October 12, 2004

Subject: Request for Opinion Letter  
Convention Center Expansion  
Corrective Action Plan Amendment and Replacement  
Monitoring Well Locations  
Spokane, Washington  
File No. 0110-047-07

Figure 3, Historic Subsurface Exploration Map, Revised

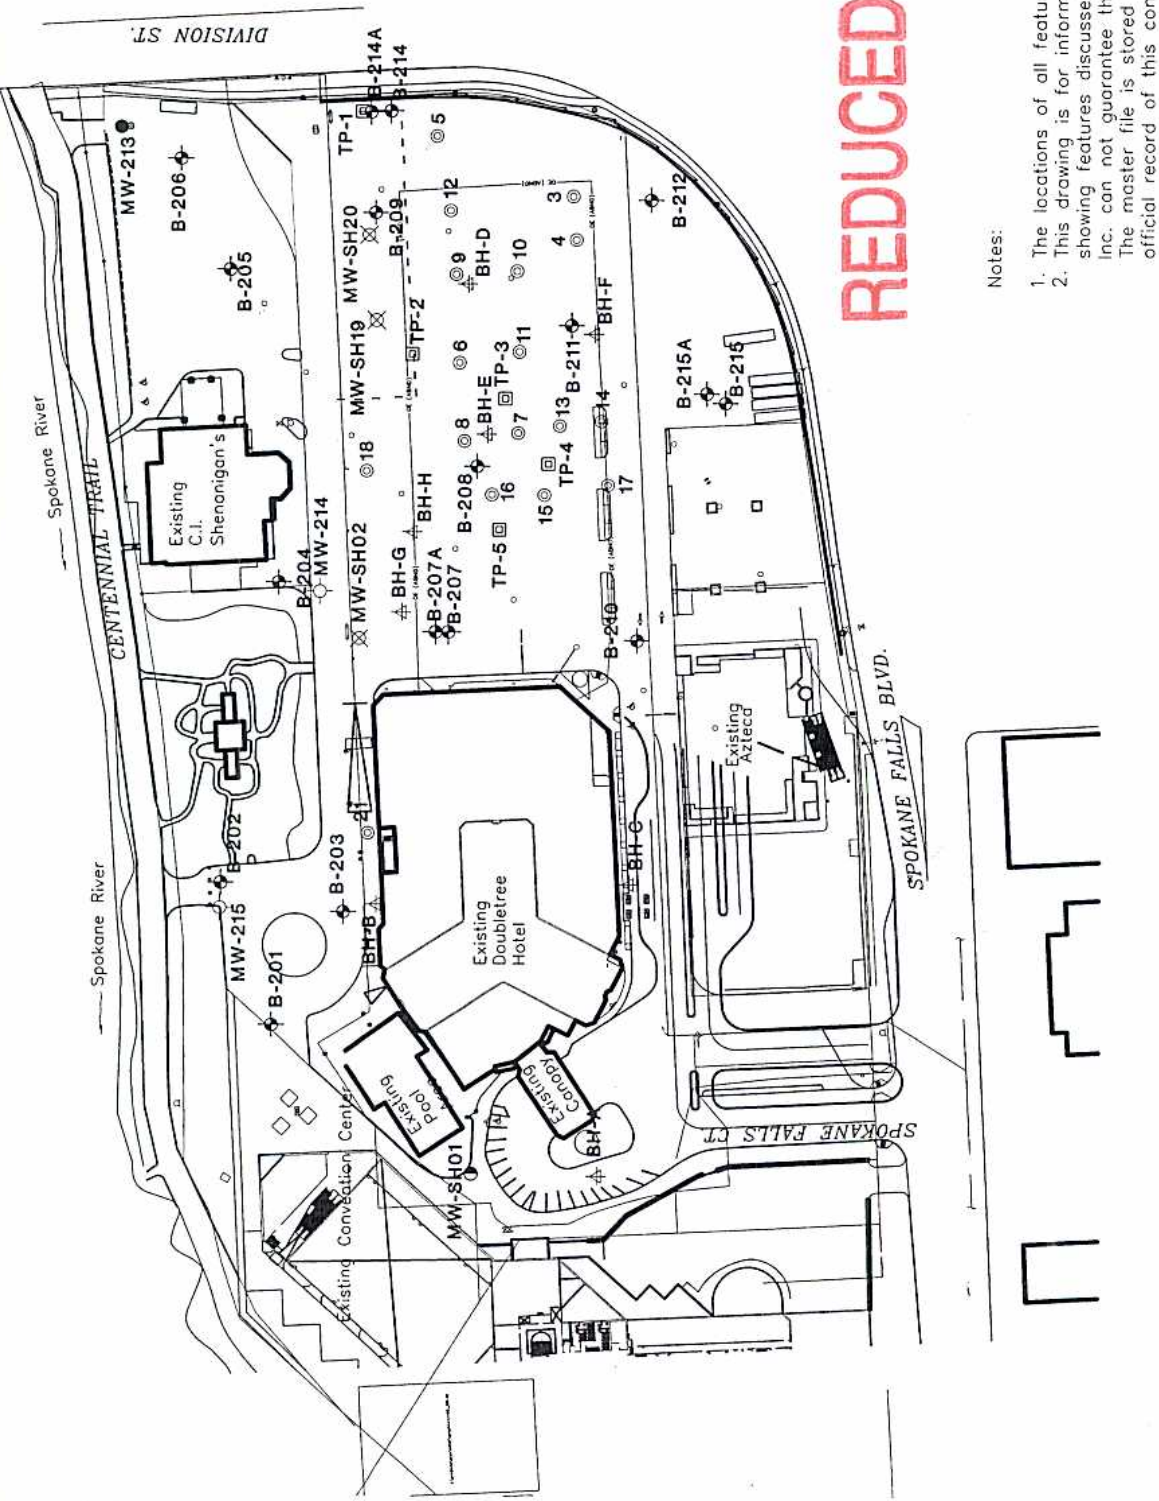
The SPFD intends to install two replacement monitoring wells at the following areas:

1. MW-214, near the southeast corner of the East-West Arbor Park (north of former monitoring well MW-SH02). This well will document groundwater conditions north of the new CCX facility and downgradient of the main remedial area.
2. MW-215, north of the existing Doubletree Hotel facility. This well will document groundwater conditions in the western portion of the new CCX facility and downgradient of the western remedial area.

Installation and maintenance of a third monitoring well north of former monitoring wells MW-SH19 and MW-SH20 will be difficult because the CCX facility is being built up to the SPFD northern property boundary in this location. A well located in this area might be damaged during construction if drilled before earthwork is completed, and it will be difficult to drill after construction is completed because of the presence of the CCX structure. Existing monitoring well MW-SH01 will continue to be used to document groundwater conditions in the western portion of the site. Existing monitoring well MW-213 will continue to be used to document groundwater conditions along the east property boundary. Figure 3 from the CAP, Historic Subsurface Exploration Map, is attached and has been revised to show abandoned and proposed monitoring well locations. Note that these locations might be moved slightly to accommodate site utilities.
